SUBJECT: Donald C. Cook Nuclear Plant Unit 1
Docket No. 50-315
Response to Request for Additional Information Regarding the Reanalysis of Unit 1
Small Break Loss-of-Coolant Accident

Enclosure 1 to AEP:NRC:8046

Figure 4-1

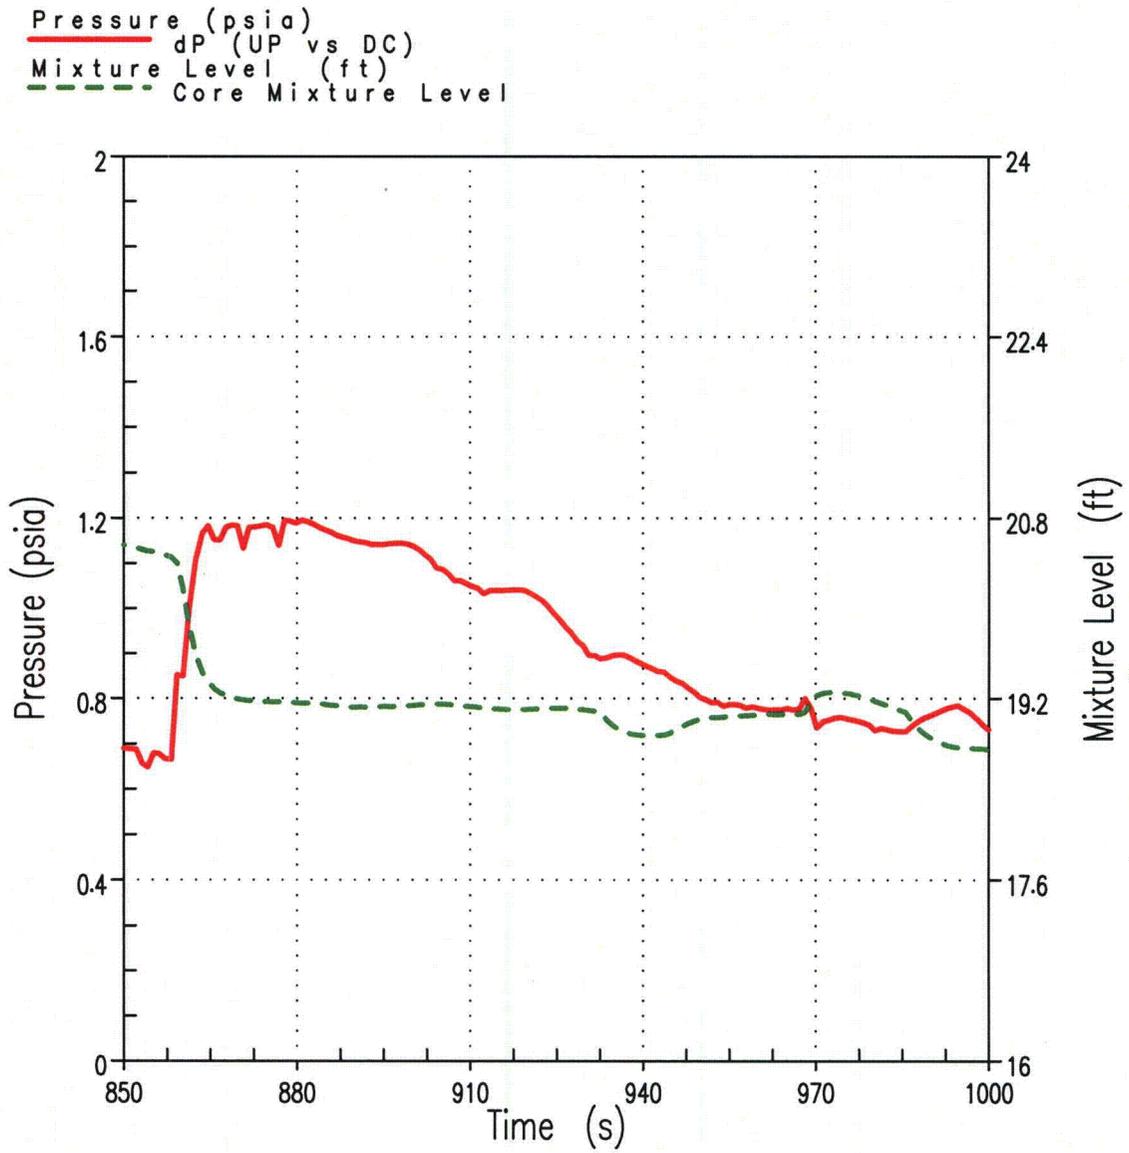
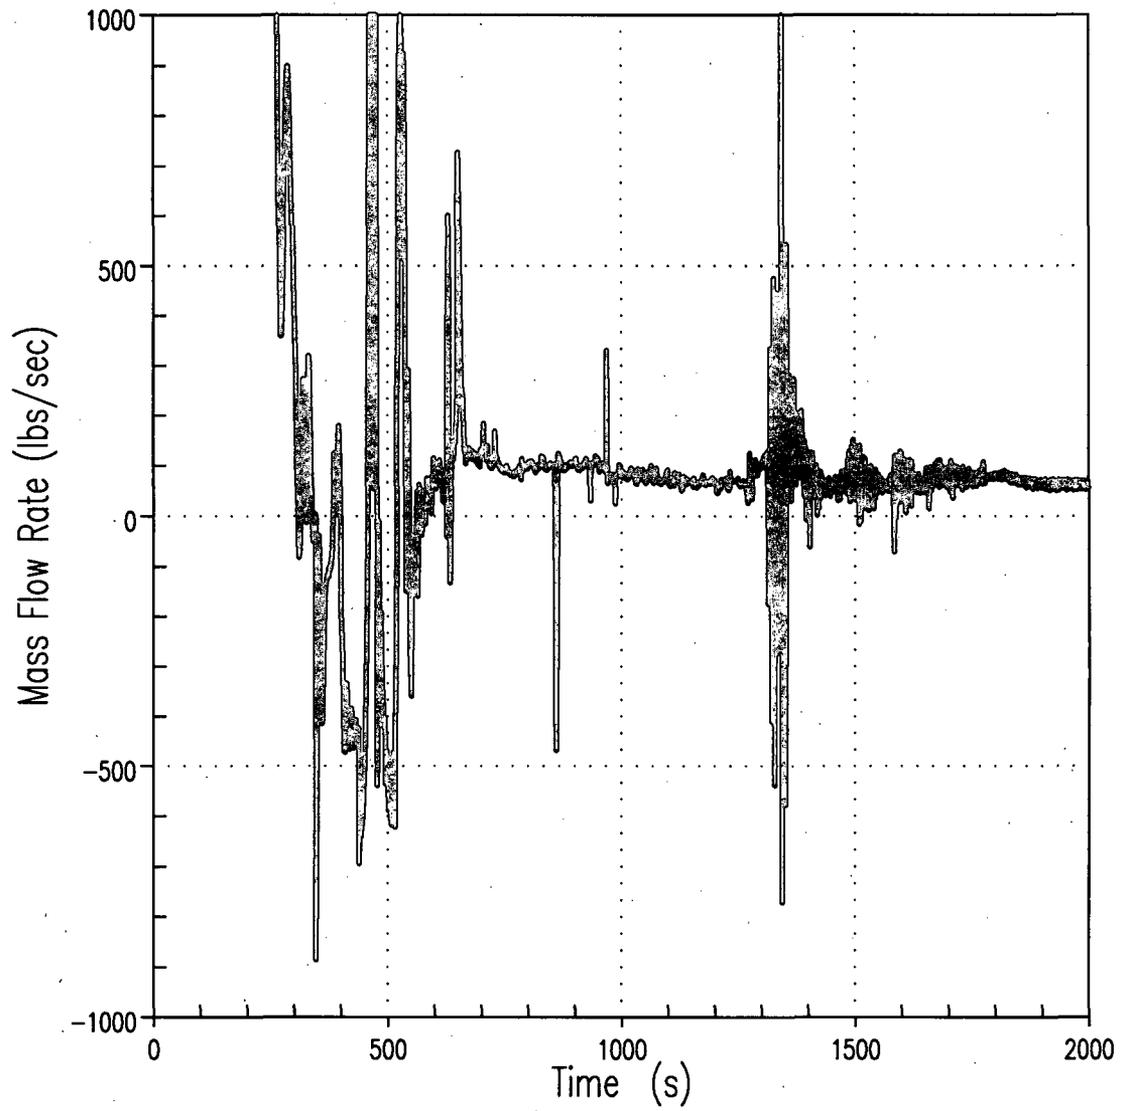
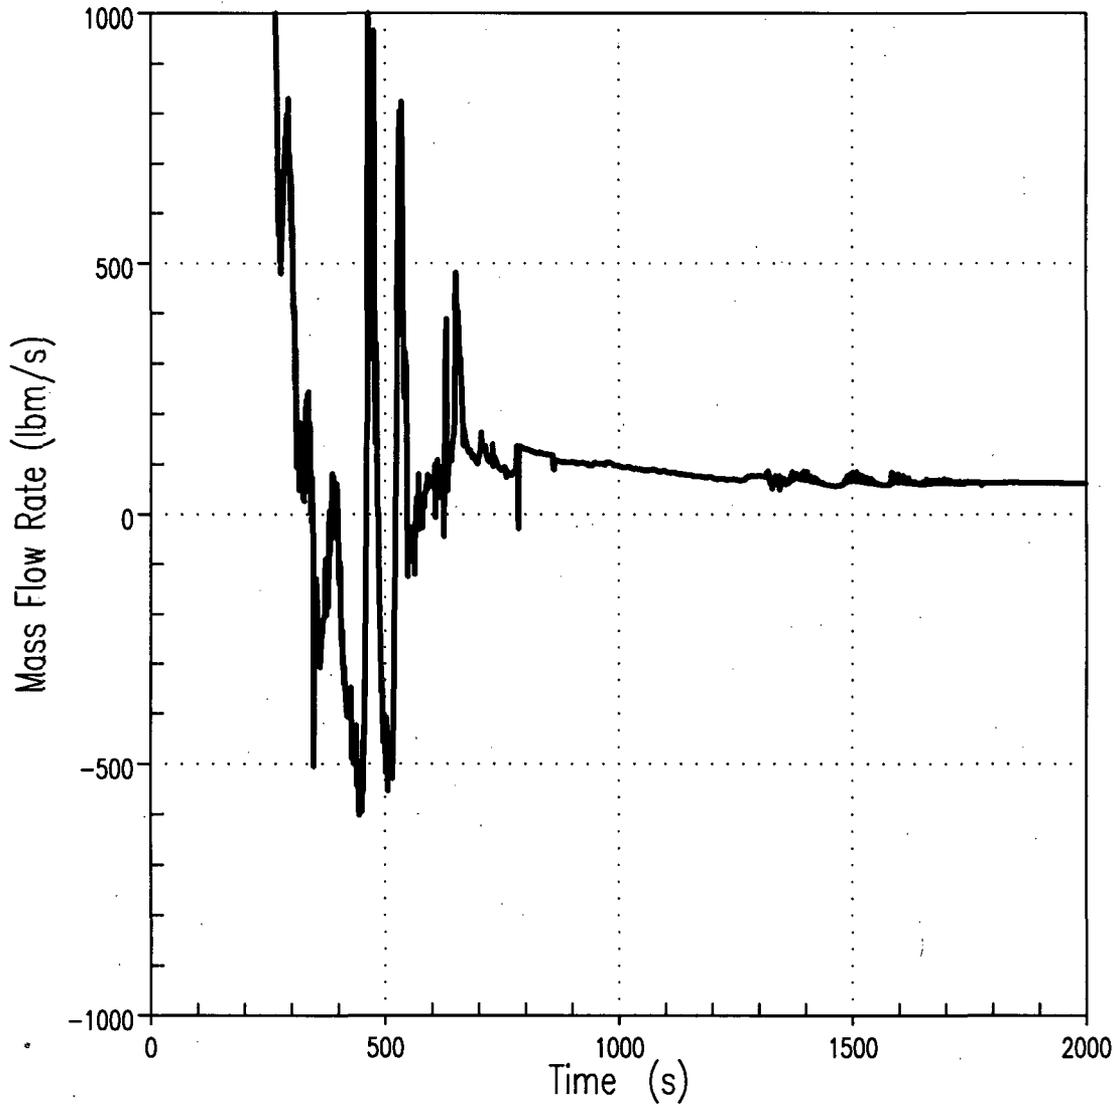
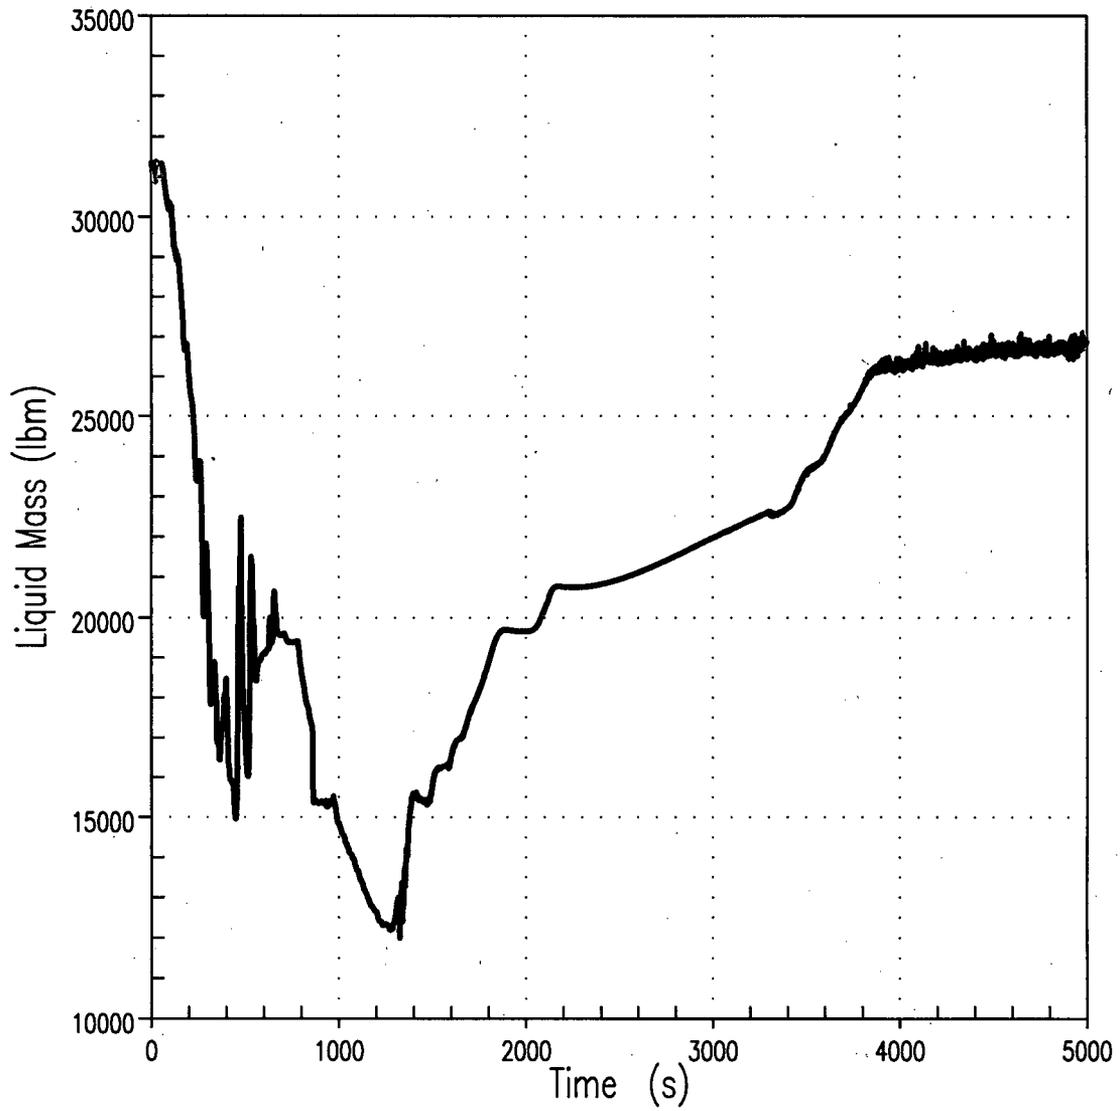
Please explain the cause of the abrupt change in the core two-phase level which suddenly remains constant from 800 to 1000 seconds in Fig. 6, for the 3.25-inch break. Since this is a boil-off process, and the broken loop seal has cleared earlier, the abrupt termination of the level decrease during the boil-down and uncovering period is not understood. Please provide the core inlet and outlet mass flow rates and the core liquid mass vs. time for this break.

Figure 4-1 of this enclosure illustrates the sudden increase in pressure differential between the upper plenum (UP) and the downcomer (DC) at approximately 860 seconds, resulting in a depression of the mixture level. This excessive differential pressure is attributed to model numerics and is considered unrealistic. Moreover, this behavior is considered to be a conservative response. However, this situation corrects itself and as the pressure differential decreases, the depression is relieved and the mixture level demonstrates this as a termination of the level decrease during boil-down. After approximately 1000 seconds the normal boil-down process drives the mixture level response.

Figure 4-2 provides the core inlet mass flowrate, Figure 4-3 provides the core outlet mass flowrate, and Figure 4-4 provides the total core liquid mass.

Figure 5-1

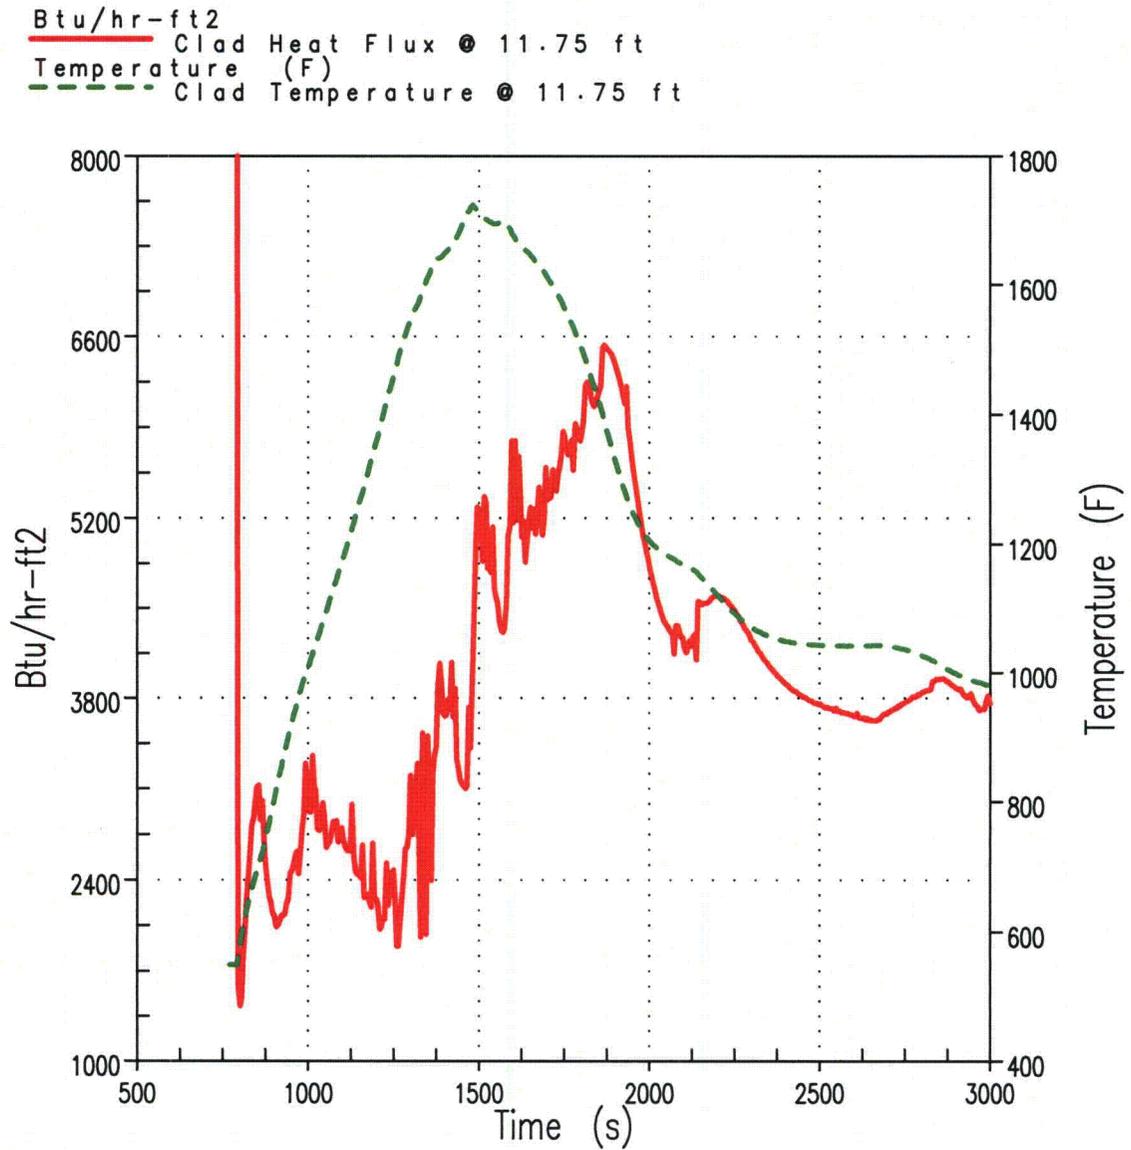
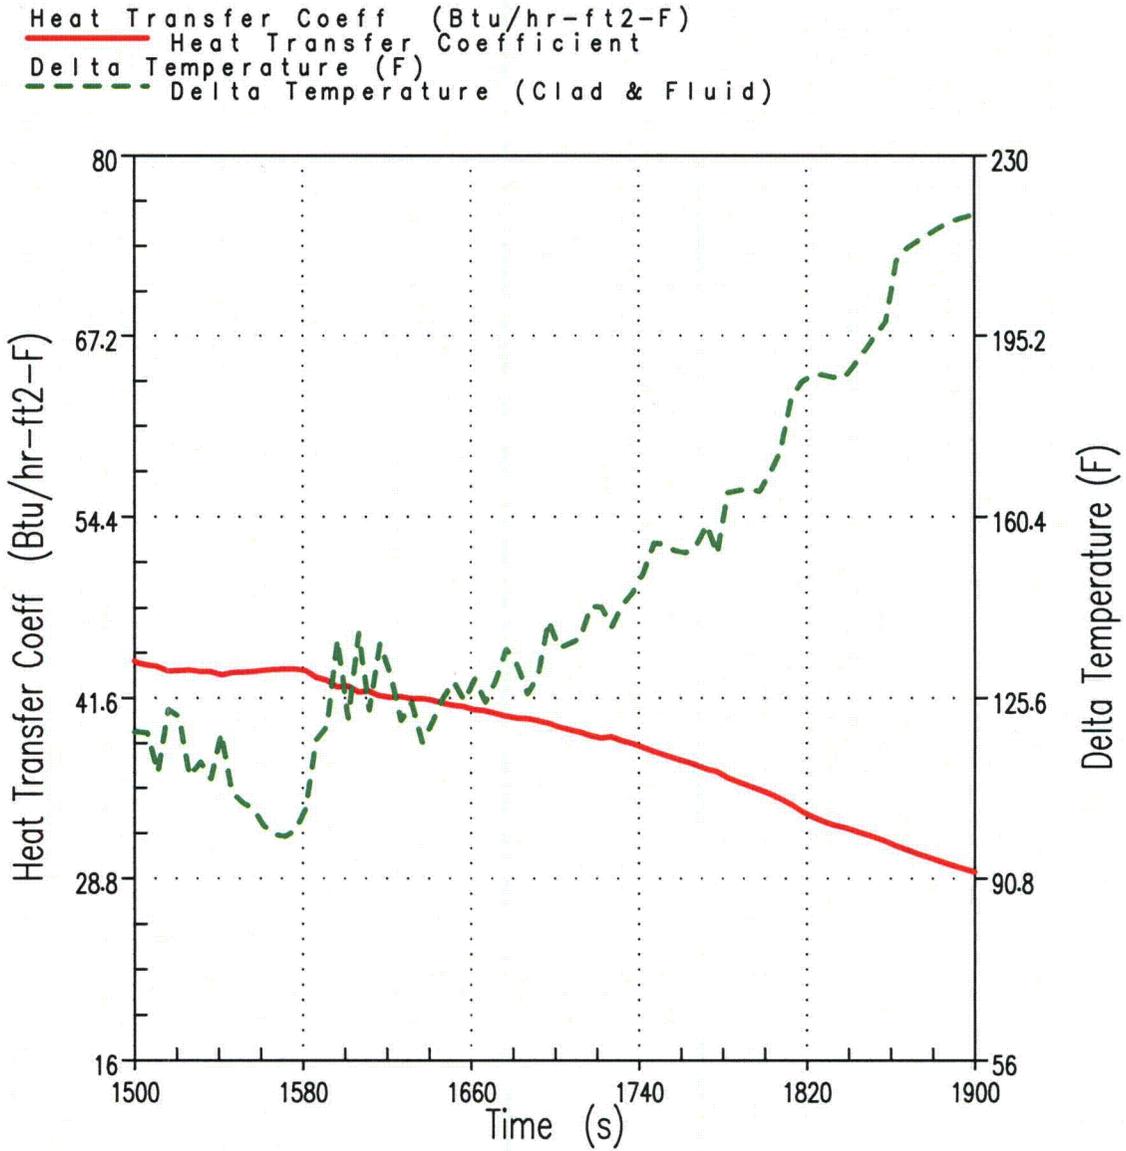
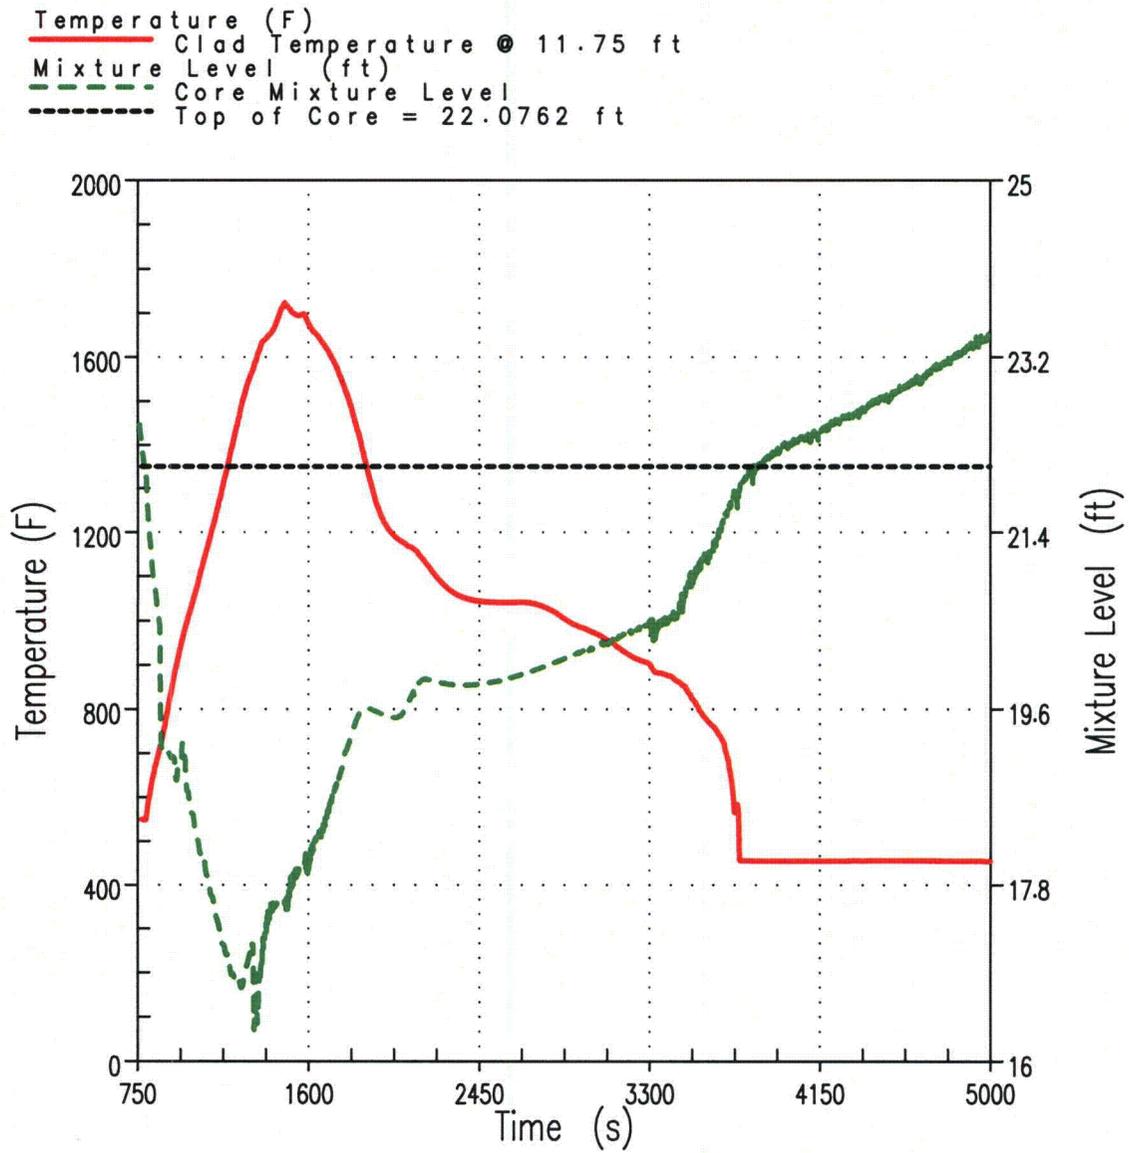
The peak cladding temperature (PCT) turns over at about 1500 seconds for the 3.25-inch break in Fig. 14, at which time the heat transfer coefficient peaks during steam cooling shown in Fig. 15. At 1800 - 2000 seconds, the heat transfer coefficient drops below the value that produced the earlier heatup from 800 to 1500 seconds, yet the clad temperature continues to decrease. Please explain.

The steady decrease in PCT from approximately 1500 to 1900 seconds for the 3.25-inch break can be attributed to higher heat flux (clad heat removal rate) during this period. As seen in Figure 5-1, after the PCT turns around at about 1500 seconds, the heat flux (heat transfer between the clad and the surrounding fluid) at the PCT elevation of 11.75 feet continues to remain above the value that produced the earlier heat up until approximately 1900 seconds. Figure 5-1 also illustrates that the rate of PCT decrease slows down after 1900 seconds due to the lower heat flux at this time.

Figure 5-2 is provided to clarify this further. The clad heat removal depends on both the heat transfer coefficient as well as the temperature difference (ΔT) between the clad and the surrounding fluid. The magnitude of the fluid temperature is impacted by accumulator injection during approximately 1500 to 1900 seconds which results in a fluid temperature decrease and subsequent ΔT increase as illustrated by Figure 5-2. Figure 5-2 also illustrates that during the time period of interest here (1500-1900 seconds), the variation in heat transfer coefficient is smaller in magnitude and is offset by the increase in ΔT , which in turn aids in the PCT decrease.

Figure 5-3 is presented to show that clad heat up and cool down corresponds to the uncover and recovery period.
